TO: All Design Section Staff  
FROM: Bijan Khaleghi  
DATE: April 09, 2021  
SUBJECT: Traffic Barrier Reinforcement Spacing on Bridge Deck Reinforcement Plan Sheets.

This design memorandum specifies WSDOT's policy for noting traffic barrier reinforcing bars S1 and S2 in Bridge Plans.

### 11.1.3.C – Sheet Contents: Bridge Deck Reinforcement

Figure 11.1.3-C1 Traffic barrier reinforcement callout on Bridge Deck Reinforcement plan sheet

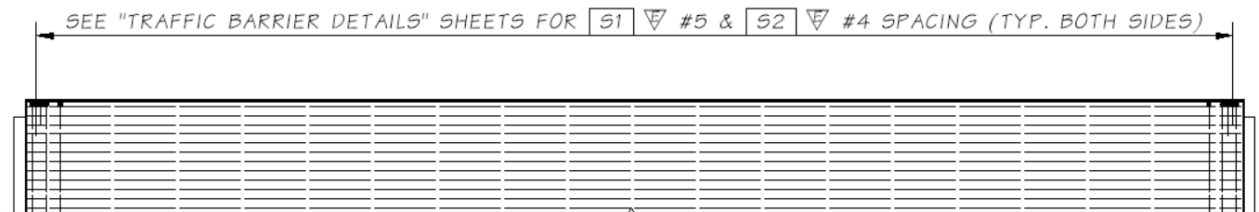
- Plan and transverse section views
- Traffic barrier reinforcing bars shall be called out on the Bridge Deck Reinforcement Plan sheet by using an overall dimension as shown in Fig 11.1.3-C1. The S1 and S2 bars are to be detailed, dimensioned, and their spacing shall be shown only on the Traffic Barrier Details 1 sheet.
